Pacific Gas and
Electric Company

PG&E Letter DCL-01-115

Docket No. 50-275, OL-DPR-80
Docket No. 50-323, OL-DPR-82
Diablo Canyon Units 1 and 2
License Amendment Request 01-05
Revision to Technical Specification 1.1, "Definitions, Dose Equivalent I-131," and Revised Steam Generator Tube Rupture and Main Steam Line Break Analyses

REVISED TECHNICAL SPECIFICATION 1.1 THYROID DOSE CONVERSION FACTORS AND REVISED STEAM GENERATOR TUBE RUPTURE AND MAIN STEAM LINE BREAK ANALYSES

Figure 15.4.3-1 Pressurizer Level

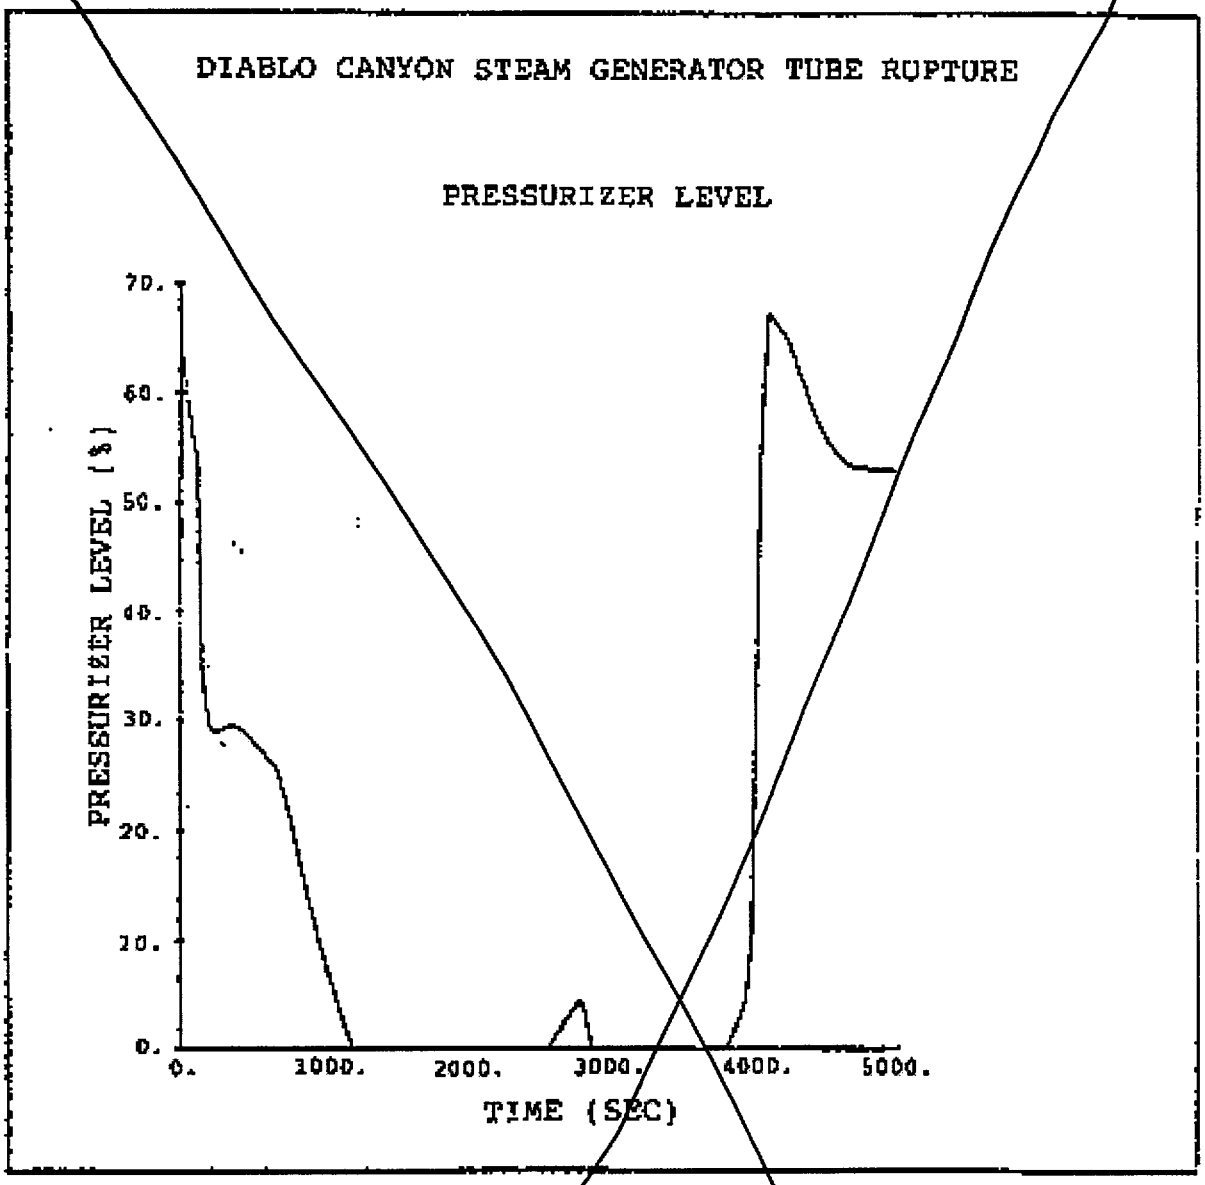
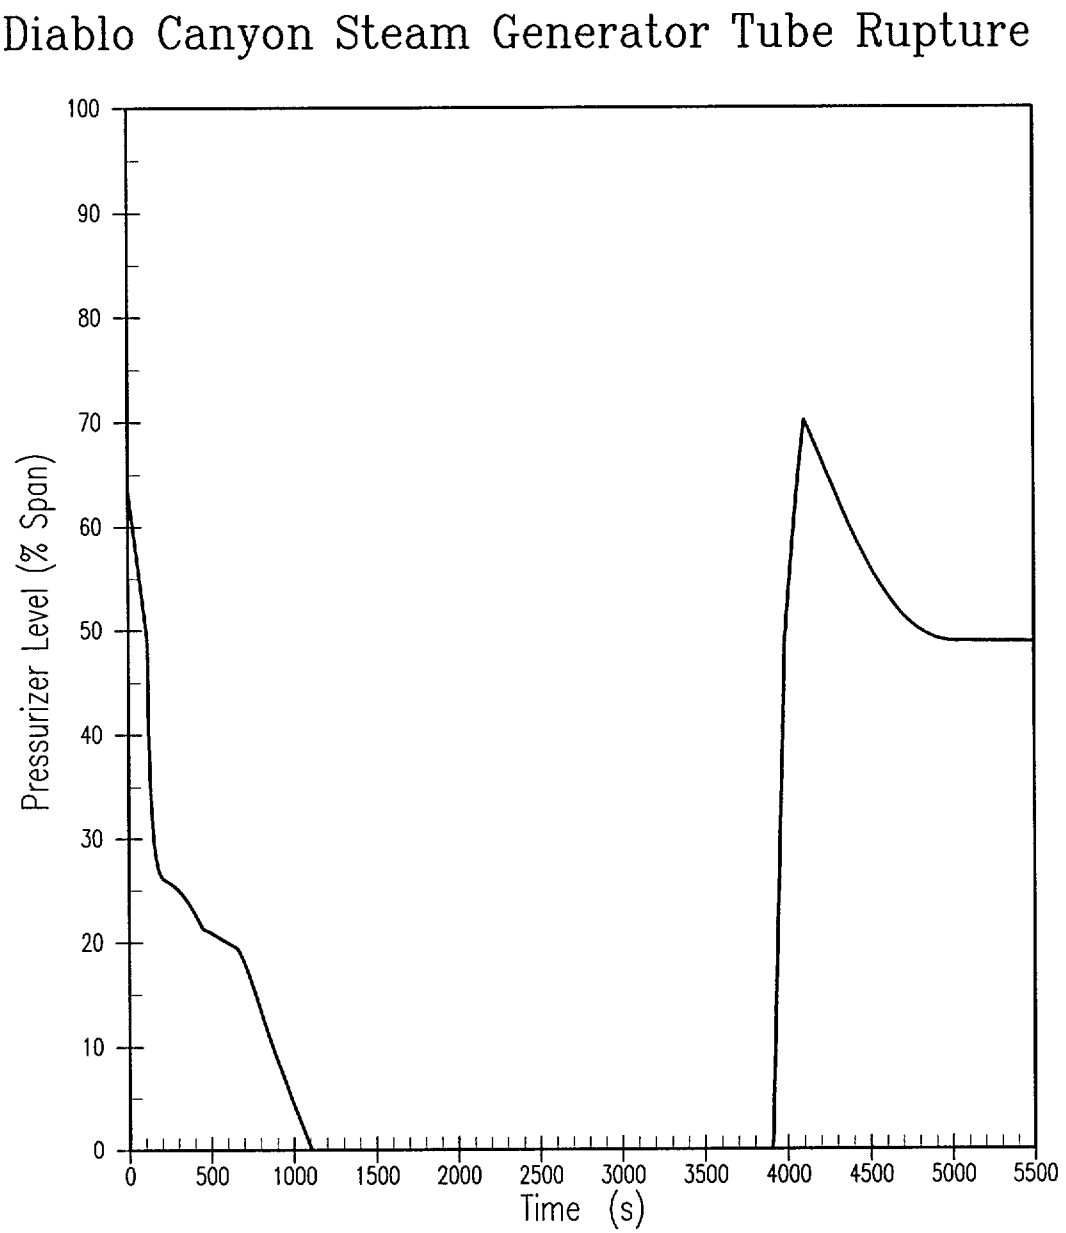
Replace with Figure 15.4.3-1

Figure 15.4-99 Pressurizer Level

Figure 15.4.3-2 Pressurizer Pressure

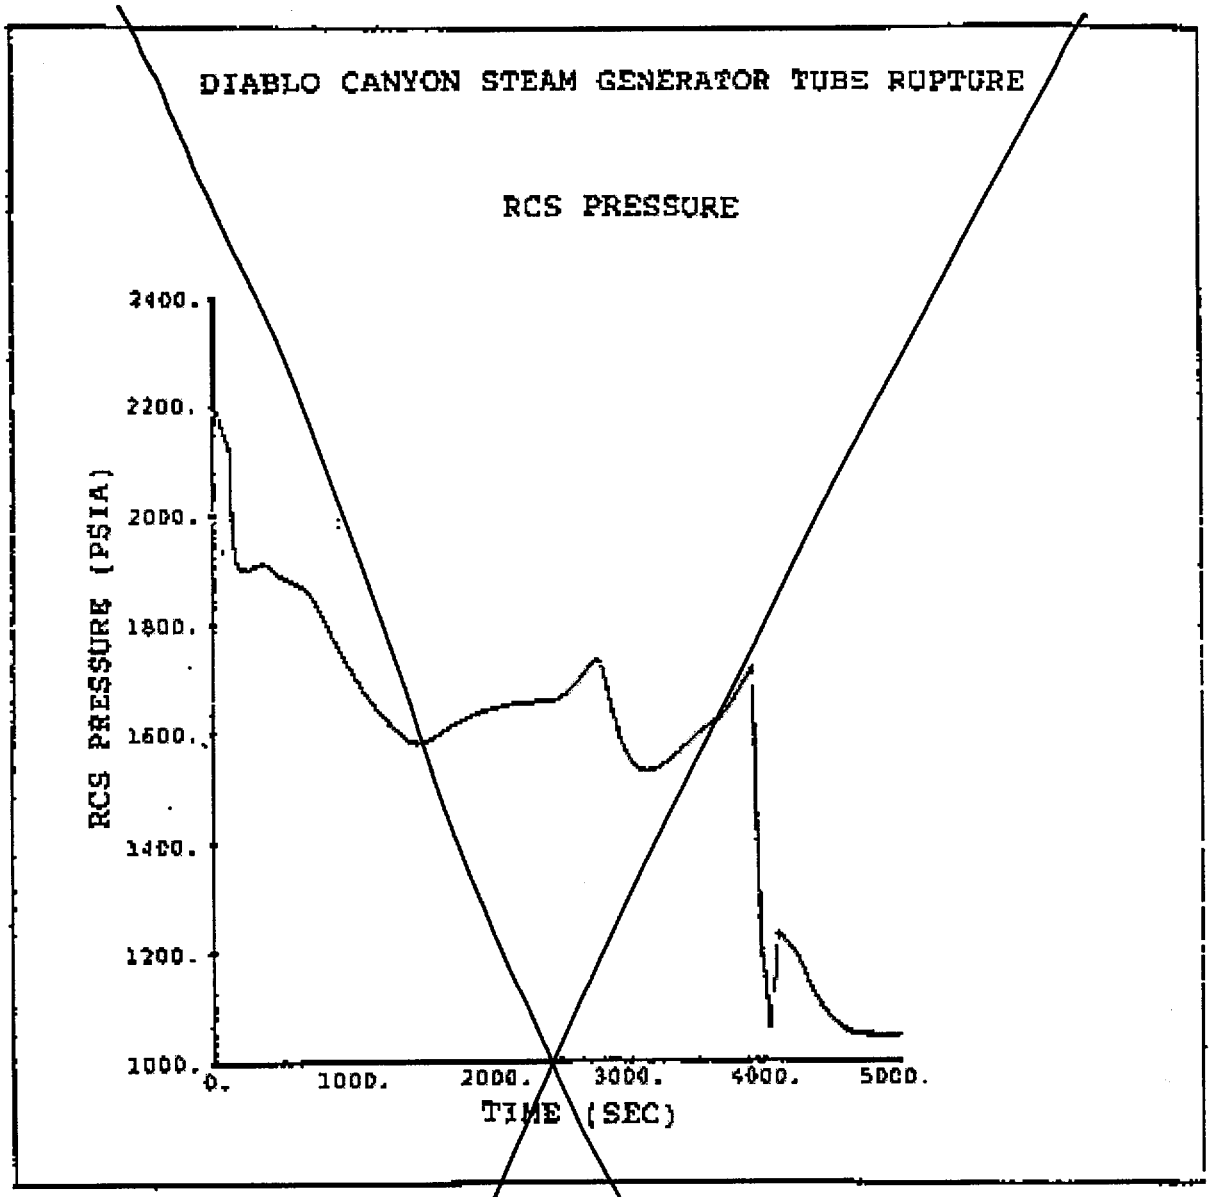
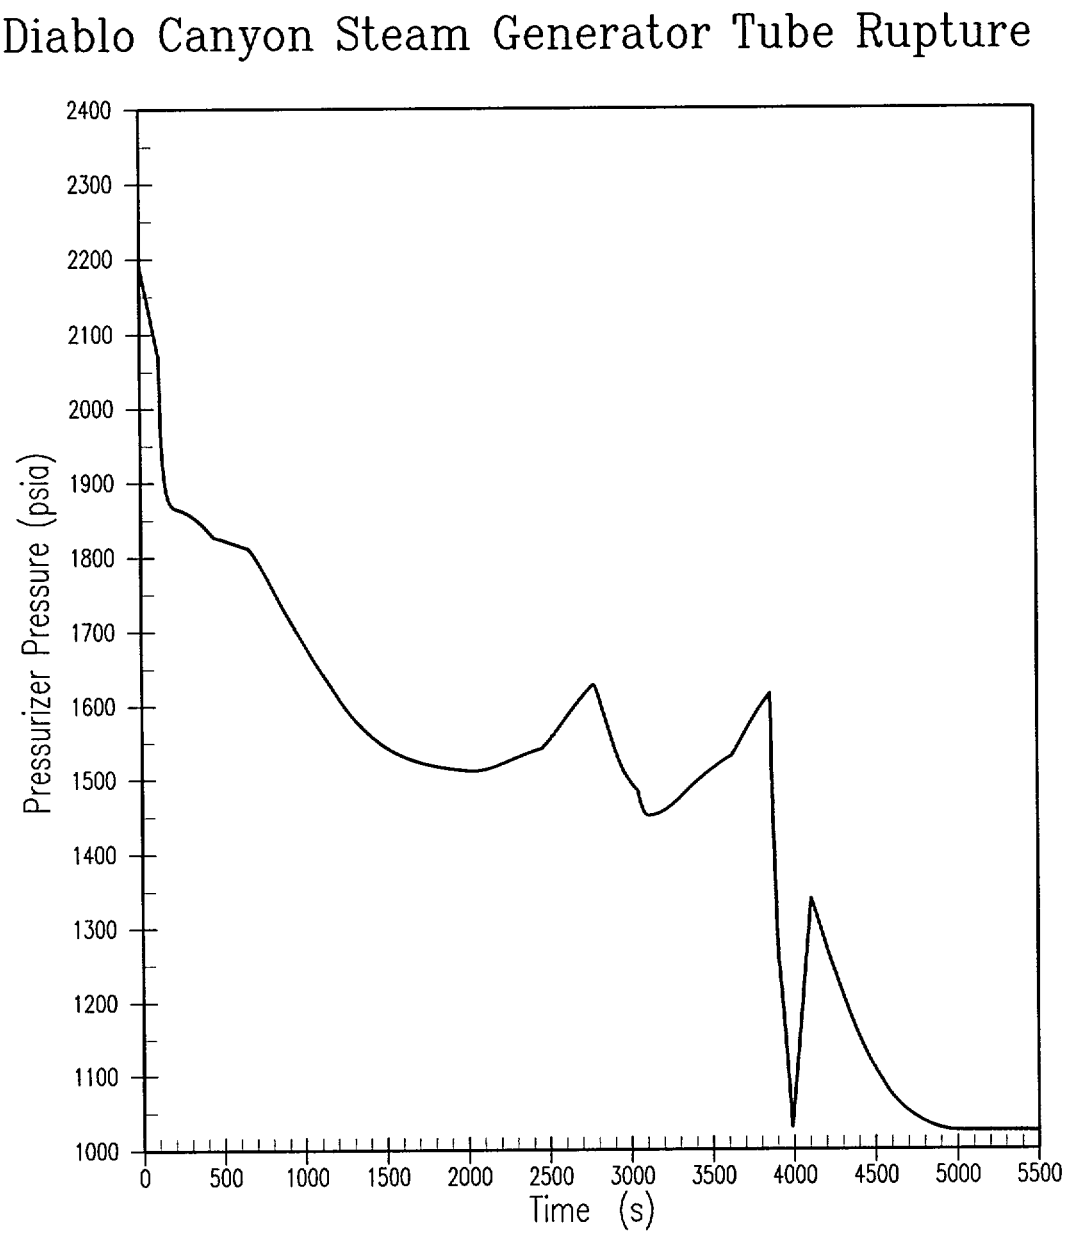
Replace with Figure 15.4.3-2

Figure 15.4-100 RCS Pressure

Figure 15.4.3-3 Secondary Pressure

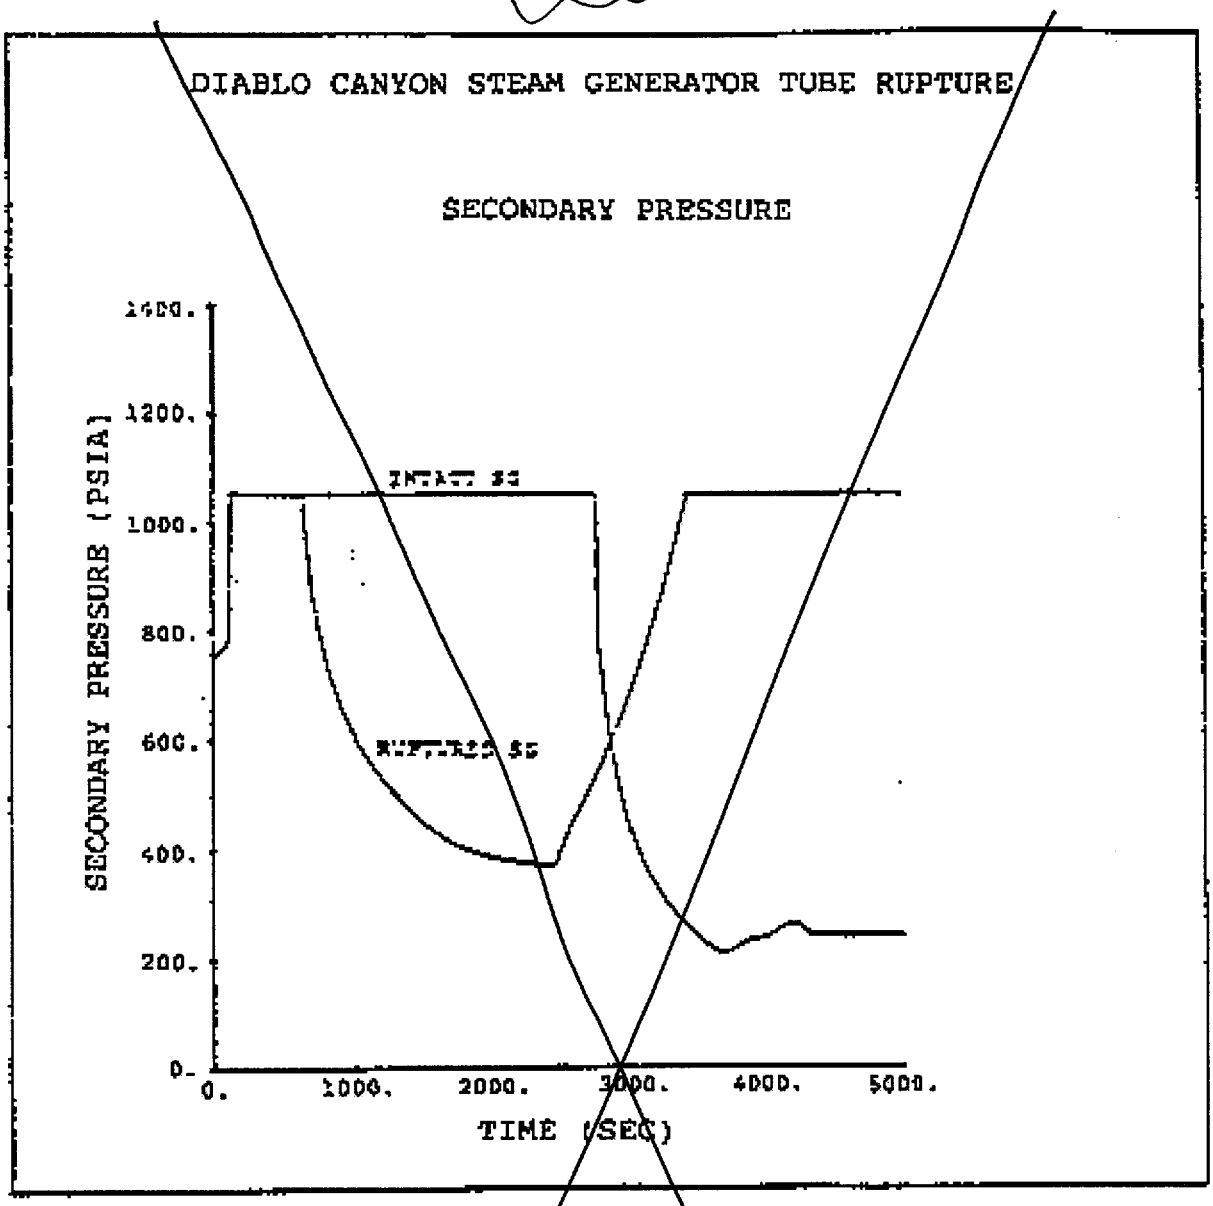
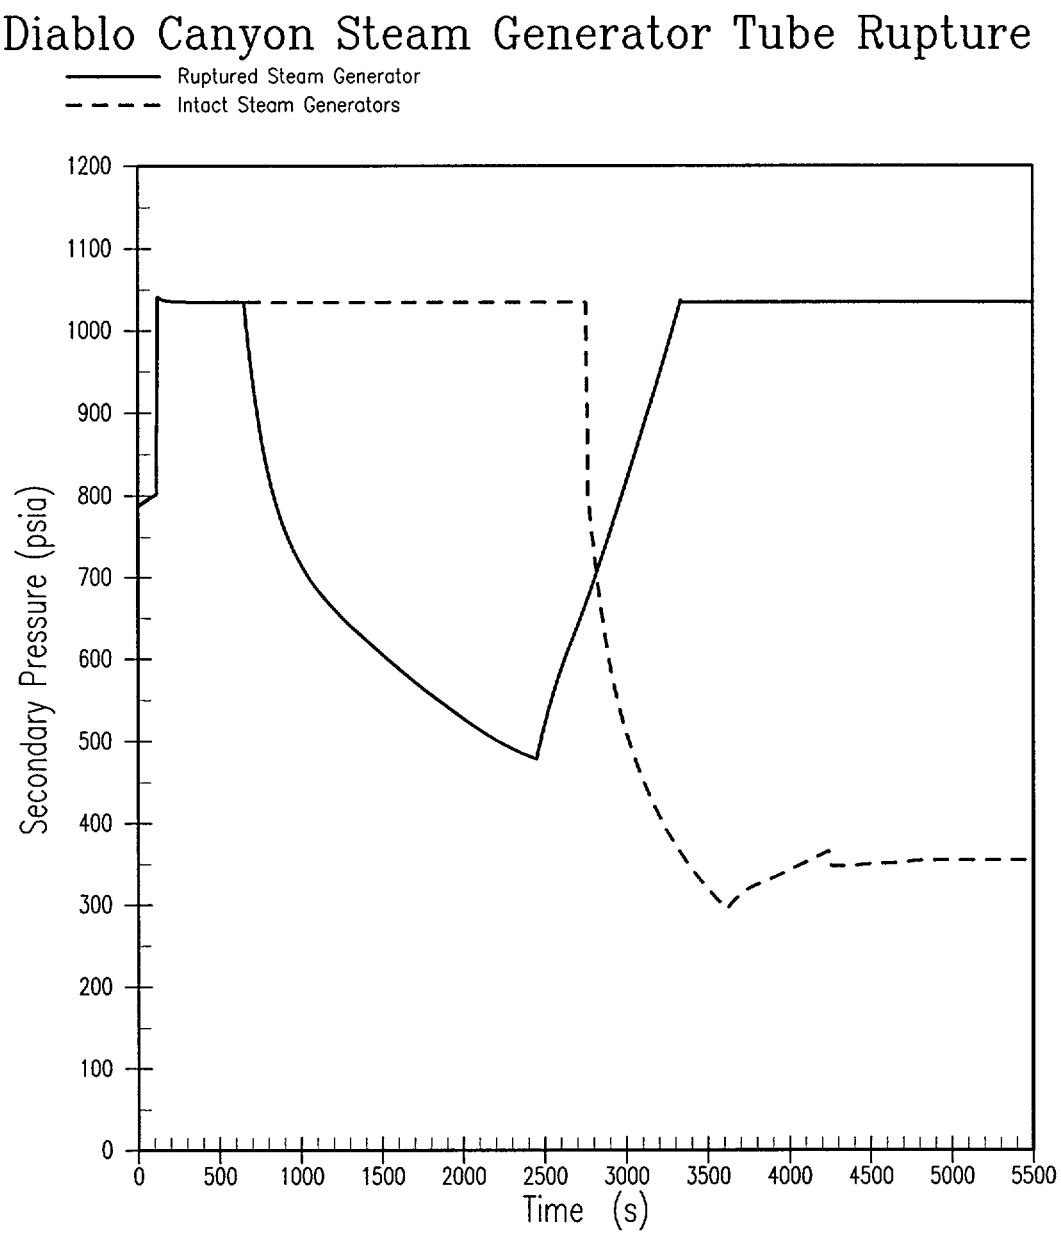
Replace with Figure 15.4.3-3

Figure 15.4-101 Secondary Pressure

Figure 15.4.3-4 Intact Loop Hot and Cold Leg RCS Temperature

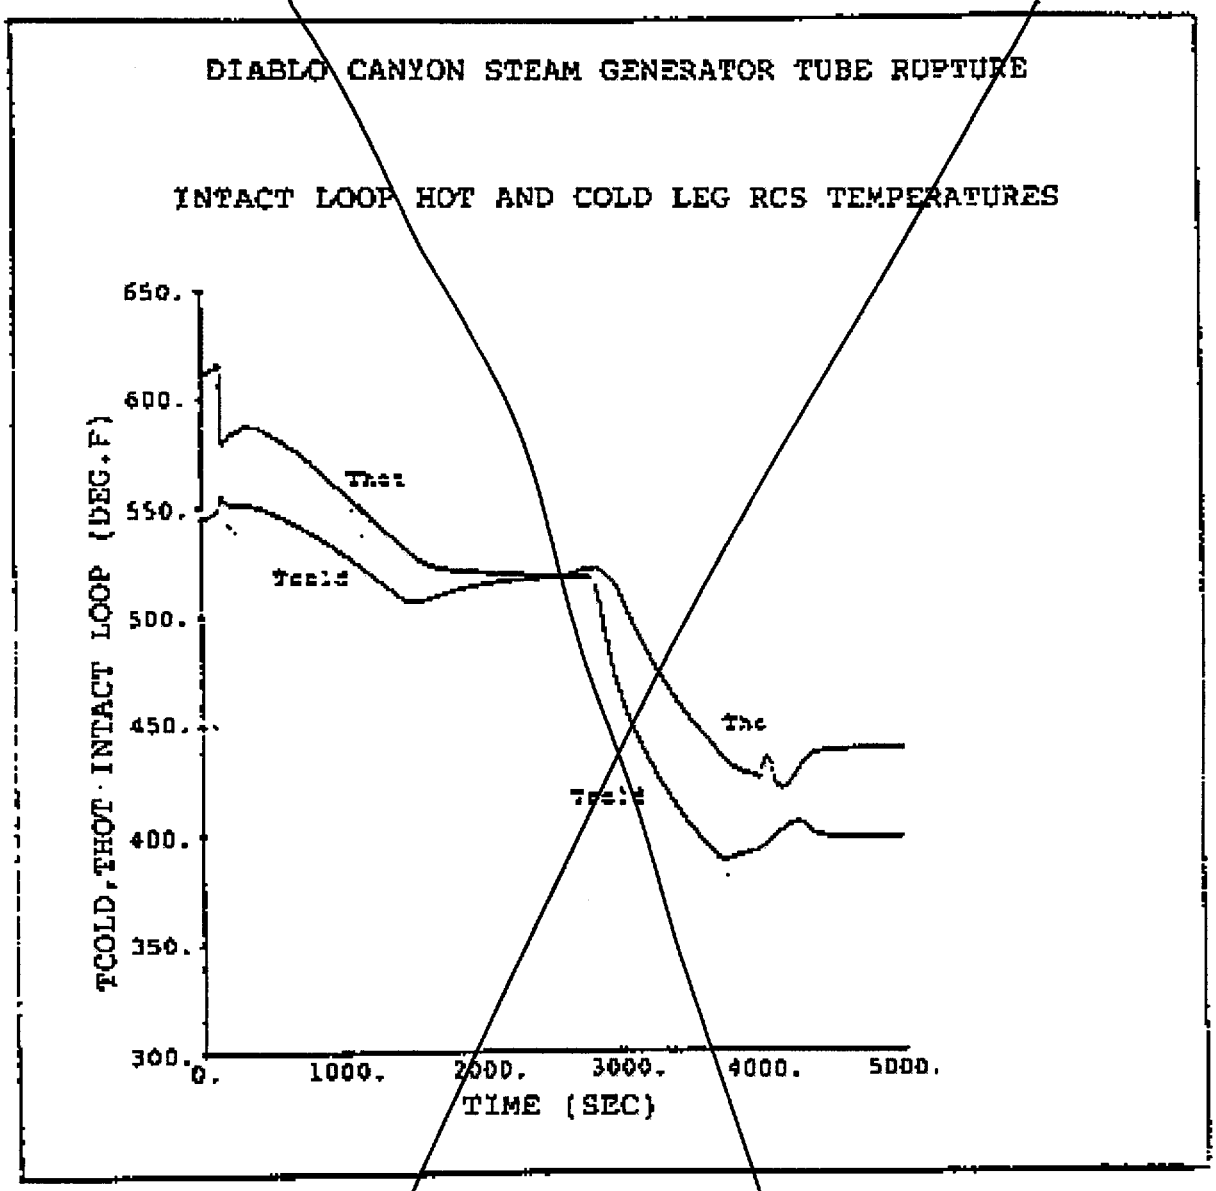
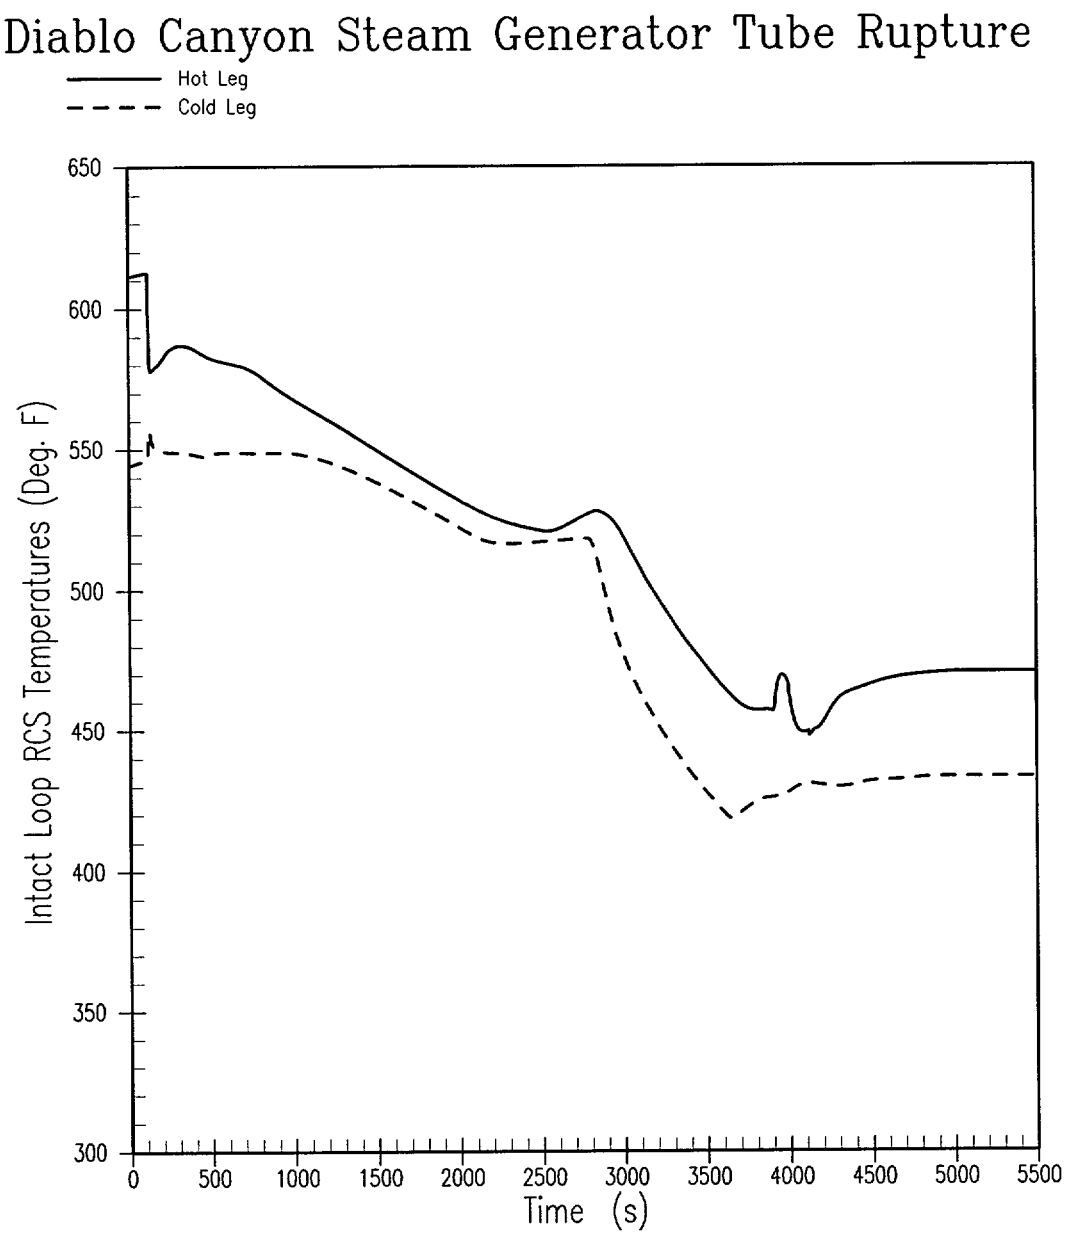
Replace with Figure 15.4.3-4

Figure 15.4-102 Intact Loop Hot and Cold Leg RCS Temperature
